Cherrywood Pointe of Bloomington

Cover Sheet

PL201900139
PL2019-139

Site Plan

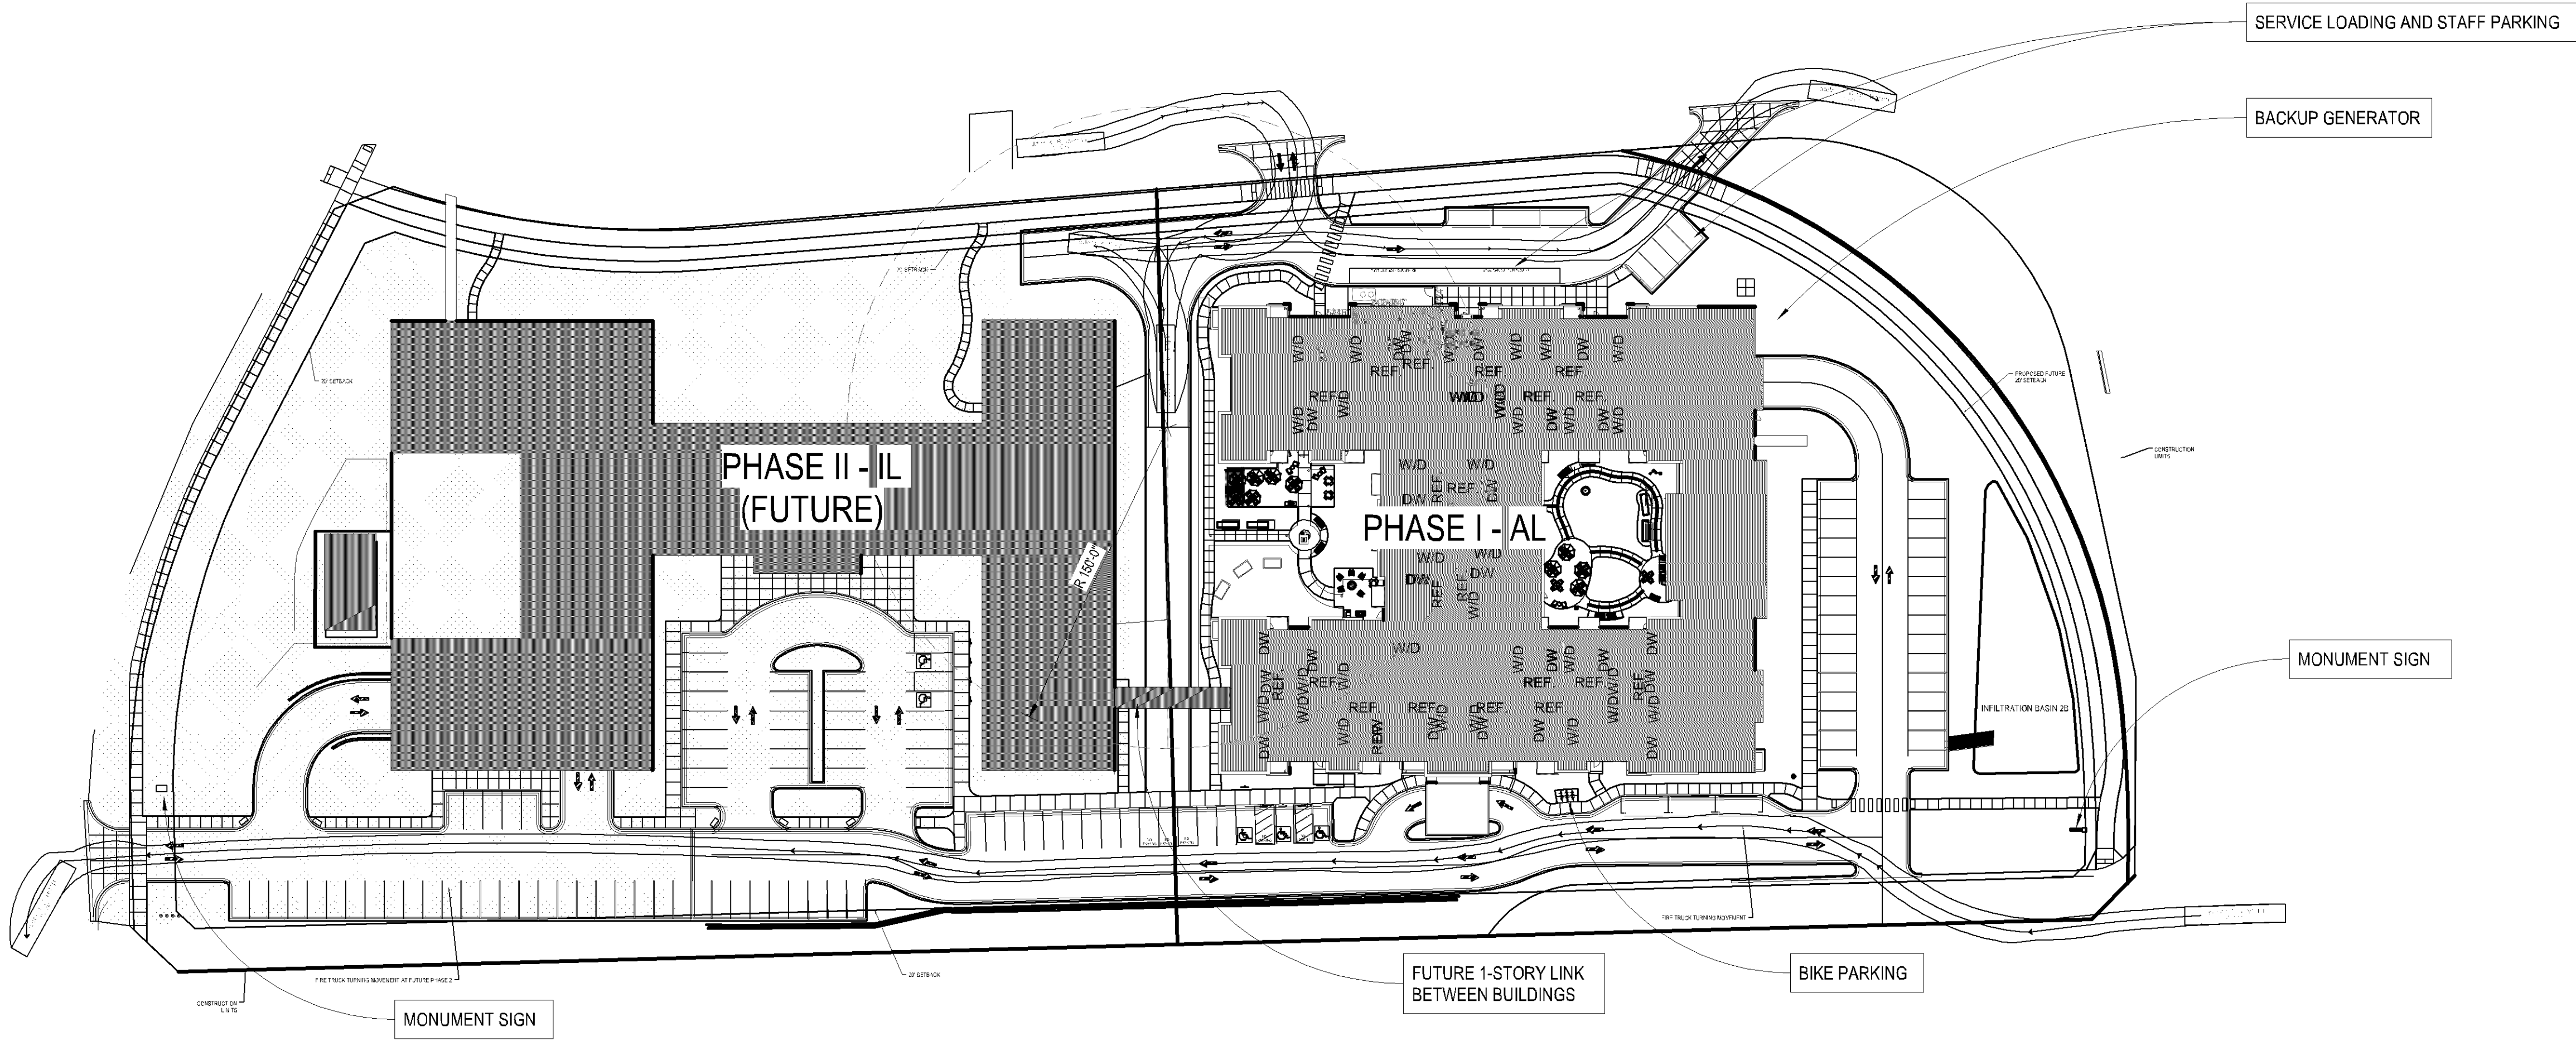
Hydrant coverage shall be provided within 50' of the FDC and within 150' of all portions of the structure.

Emergency responder radio coverage meeting the requirements of appendix L in the 2015 MSFC shall be provided throughout the property and within the structures.

Level -1

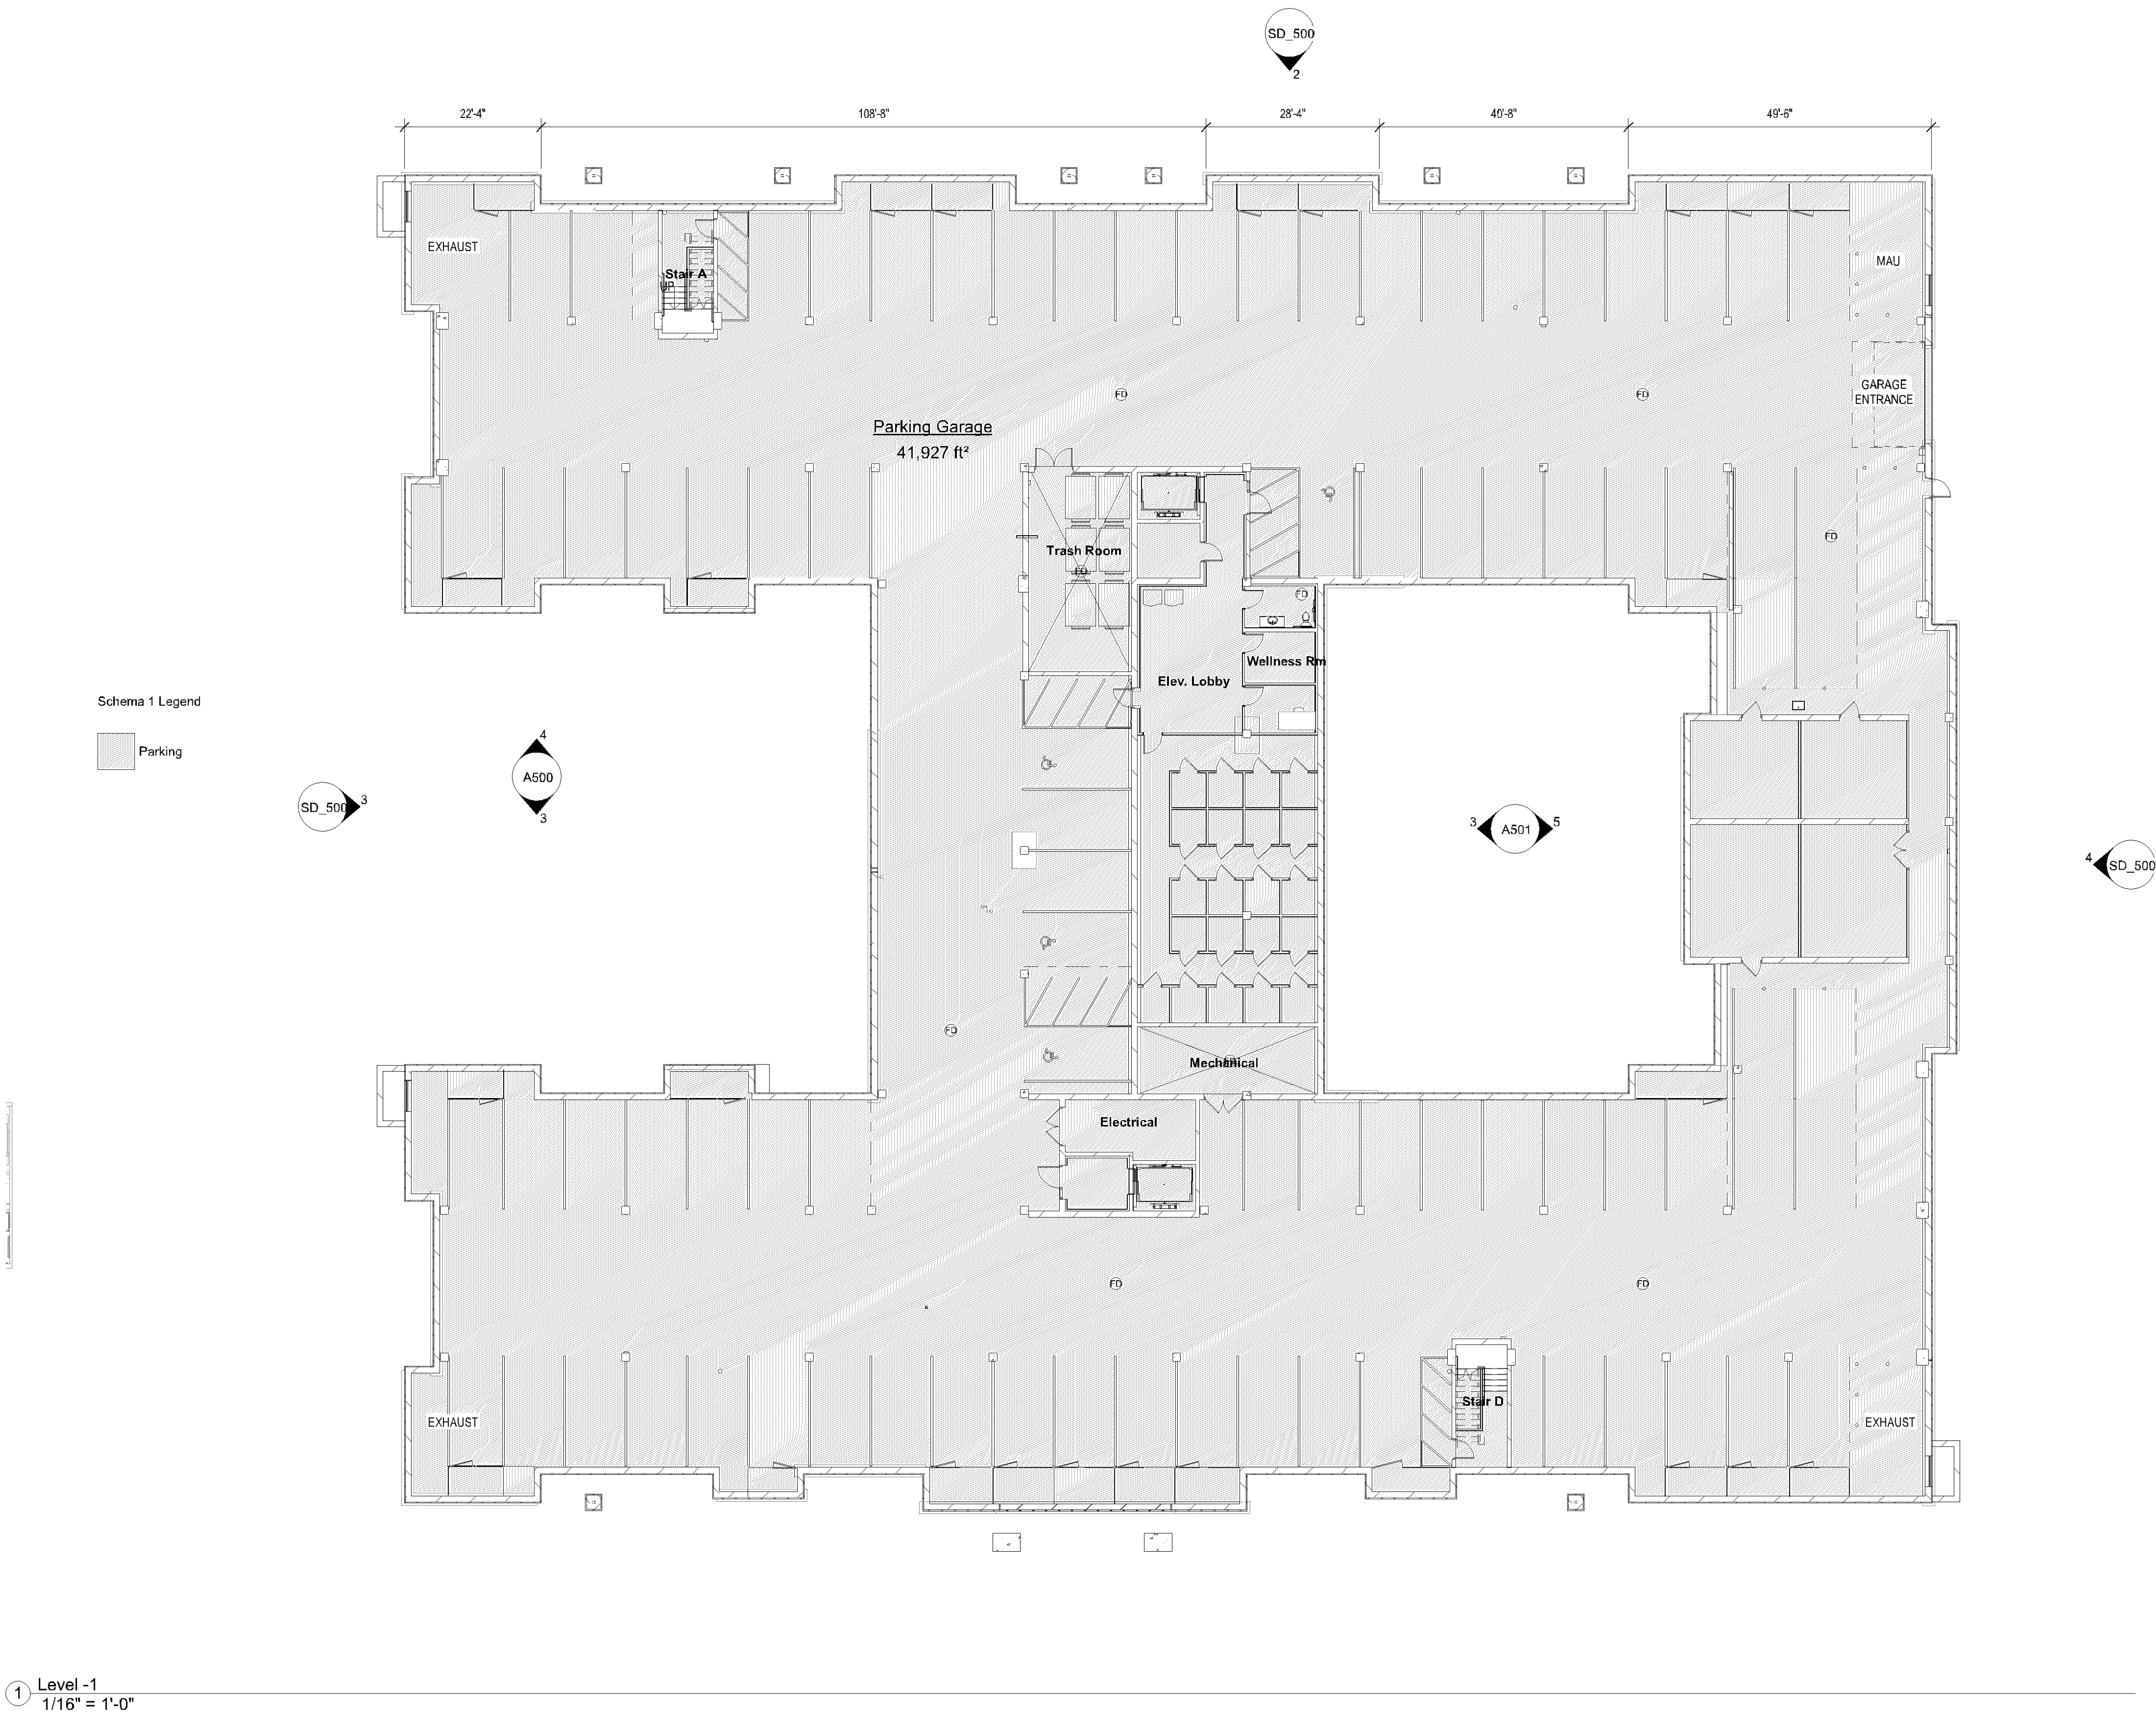
Hose valves shall be provided throughout the lower level of the parking garage within 130' of all areas of the garage if dry standpipe or within 200 feet if installing a wet standpipe
